Response to Peer Review Comments on IWEM 3.0

Final

June 2015

Office of Resource Conservation and Recovery
Office of Solid Waste and Emergency Response
U.S. Environmental Protection Agency

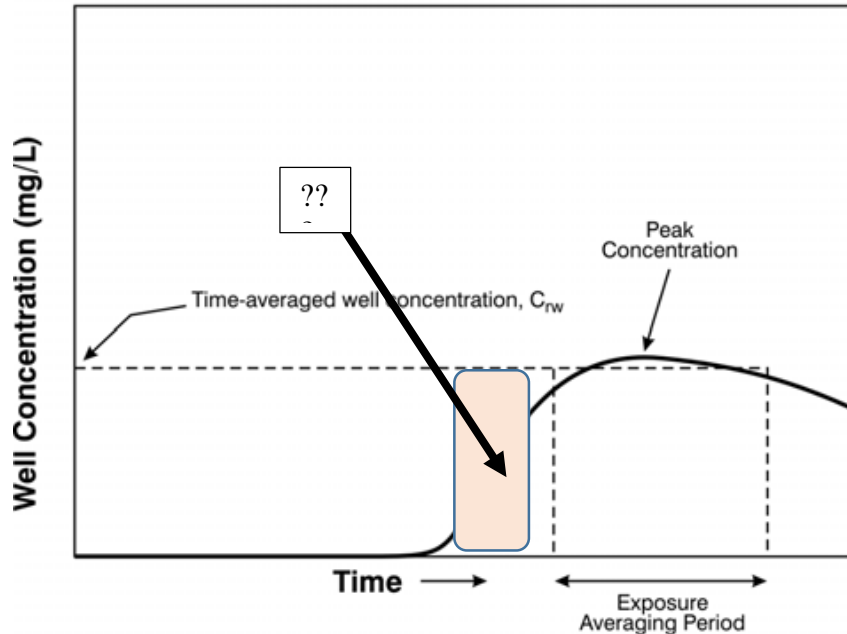
Page 4-1, Figure 4.1: What if the exposure averaging period belongs to another time range (see the pink domain below?) that only corresponds to (say) the raising part of the concentration breakthrough profile. Assume that the Trimester exposure period of a female is that period? Than what? Here the authors have described an ideal situation which is only one of the many possible cases. This is misleading and not correct.

Figure ES-1 Conceptual cross-section view of the subsurface system simulated by EPACMTP.

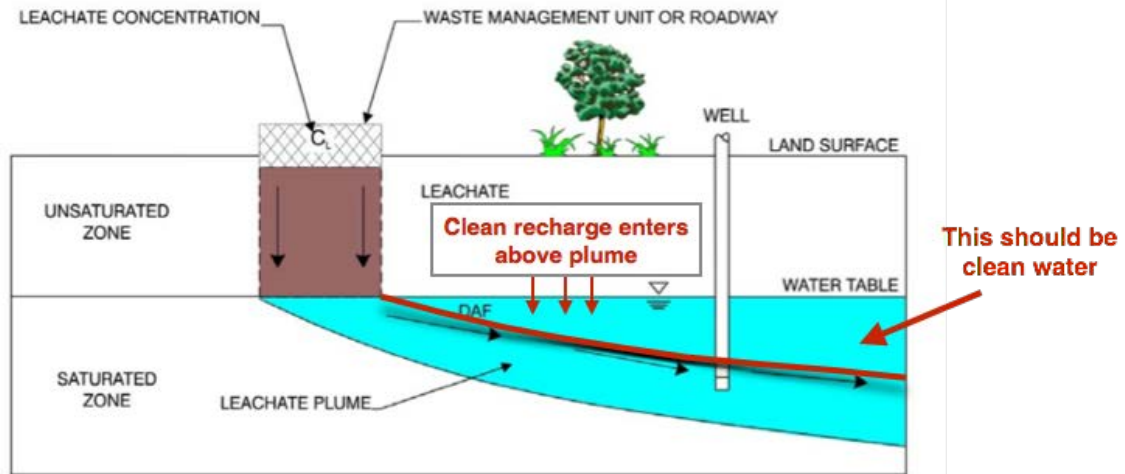
i. A set of figures (2-6 in Users Guide, ES-1, 2-3, 6-3 in the Technical Document) show a cross section through a plume emanating from a source. All of the figures show the contaminated water filling the area below the water table down to what appears to be a flow line emanating from the upstream edge of the source. Is this really what the simulated plumes look like? Does the model neglect clean recharge entering above the

plume and displacing the plume downward in the aquifer? This appears inconsistent with the description of recharge (section 6.3.3 in Technical Document). In the figure below, I show what the plume should look like. Contaminant plumes can pass beneath shallow well screens. The figures in the report appear to show that this can never happen.

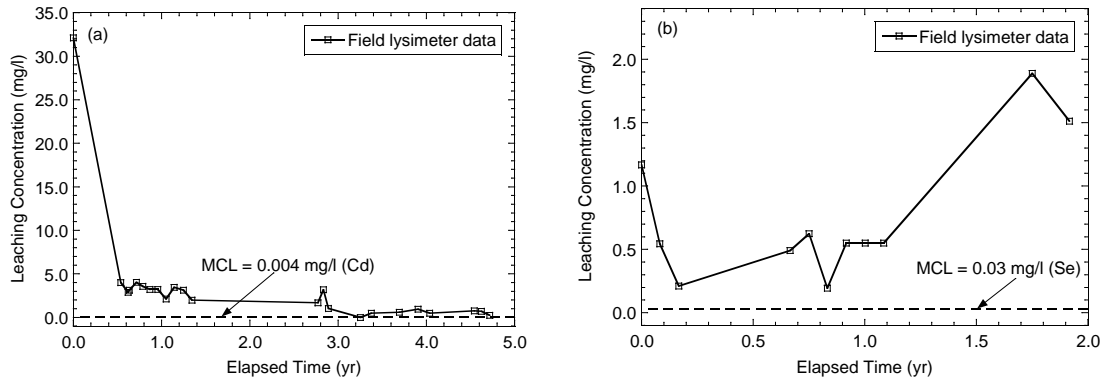
IWEM defines contaminant flux as infiltration rate multiplied by initial leachate concentration. The pulse source is assumed based on screen-level analysis and a pulse source is assumed appropriate for metals. The reference for this critical assumption is missing from the technical document. Creek and Shackelford (1992) and Sauer et al. (2012) indicate that leaching patterns for coal combustion products (CCPs) and highway materials stabilized with CCPs generally can be grouped into two classes referred to as “first flush” and “lagged response” leaching. As shown in Fig. 1, the “first flush” pattern is characterized by monotonically decreasing concentrations as water percolates through the CCPs (Bin-Shafique et al. 2006), whereas the “lagged response” pattern is characterized by decreasing concentration followed by increasing concentration. First-flush leaching patterns from CCPs generally correspond to adsorption-controlled release and can be described mathematically by advection-dispersion-reaction equation with instantaneous, linear, and reversible sorption (Bin-Shafique et al. 2006). Lagged response leaching can be attributed to a variety of geochemical processes and generally cannot be described using a single mathematical function used in WiscLEACH (Li et al. 2006). WiscLEACH was originally developed by Li et al. (2006) for assessing potential groundwater impacts associated with fly ash stabilization in roadway construction. Based on three analytical solutions for the advection-dispersion-reaction process in the subsurface, Li et al. (2006) only evaluated the “first flush” leaching pattern in the two-dimension application of fly ash stabilization. WiscLEACH was revised to extend the capacity of original WiscLEACH from a two-dimensional application of fly ash stabilization to a three dimensional application of embankment and structural fills in roadway construction. The “lagged response ”and“ first flush leaching patterns are both included in this revised WiscLEACH (Li et al. 2011). The WiscLEACH has been used in several studies of industrial materials in embankments (Cetin et al. 2013ab, Li et al. 2014).

Since the contaminant flux is critical for the IWEM prediction, it is strongly suggested to consider either to provide more detailed documentation for the current assumption, or to adopt the “first flush” and “lagged response” leaching pattern instead of pulse source.

EPA Response: EPACMTP can model the leachate source as either continuous or finite sources. Furthermore, finite sources can be modeled as a pulse or depleting sources. Both of these modeling options are available for organic constituents. However, for metals that generally exhibit non-linear sorption behavior, the depleting source term modeling option cannot be used as the analytical solution for one-dimensional transport of a solute with non-linear sorption in EPACMTP requires the simplification of the leaching profile to a constant magnitude, finite pulse (i.e., a square pulse). These metals transport capability provided by EPACMTP and its accompanying assumptions have governed the development of the roadway formulation and the primary assumption that leachate profiles are conceptualized as square pulses. More detail discussions of the pulse and depleting leaching scenarios and the underlying assumptions can be found in *Section 2.2 of the EPACTMP Technical Background Document*. In addition, the text in Section C.2.1 of Appendix C of the *IWEM Technical Background Document* has also been updated to reflect how the assumptions of the transport module have influenced the formulation of the roadway module and to improve the presentation of the pulse assumptions and methodology.

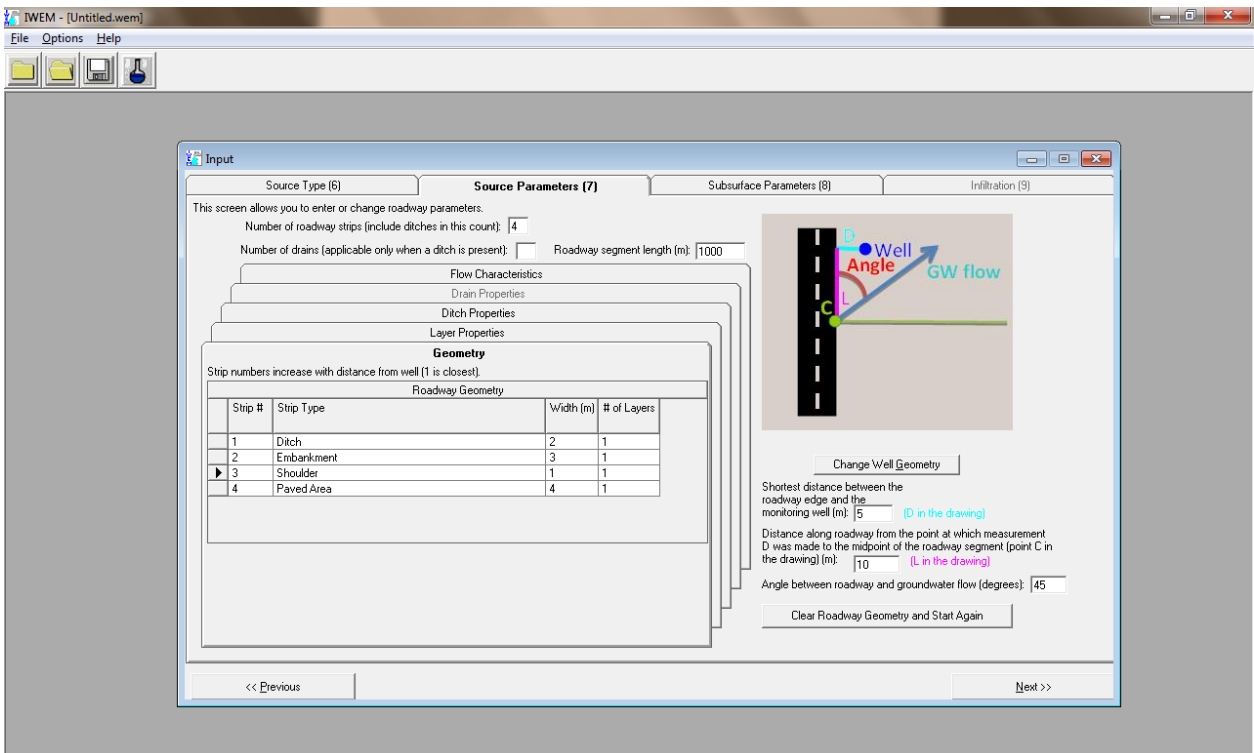
The IWEM interfaces are too old. When the user opens the IWEM, the icons of first screen are Windows 95 icons (shown in next Figure). Is it possible to change to at least Windows 7?

Figure 1: Example of a complex roadway from the report Appendix.

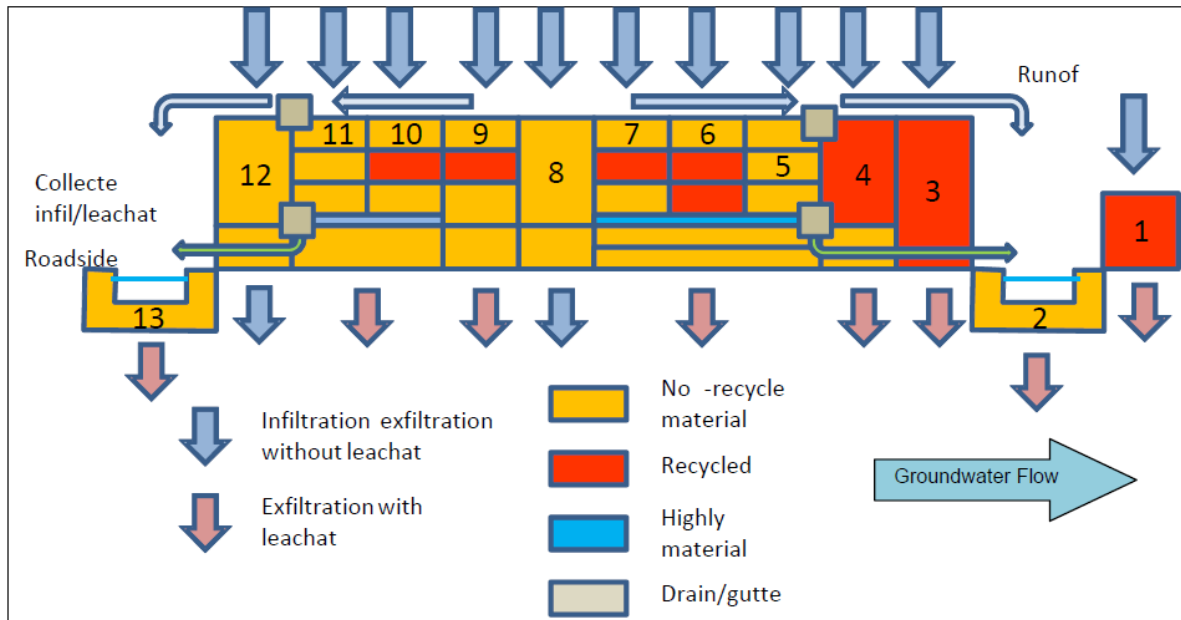
(c) Given the comments in 2 (b), I would like to comment on the development of equations for multiple road segments. If I interpret this short piece C.2.2.6 (Appendix pg. 20-22) correctly, the user needs a set of standalone tools that would take output from a sequence of IWEM runs and superimpose solutions and route mass along the ditch. I can expect that a typical user would not understand how to do such an analysis. If such a capability is desirable, then a simple worked example needs to be presented as a conceptual model, including steps explaining ditch routing and superposition of mass transport calculations.
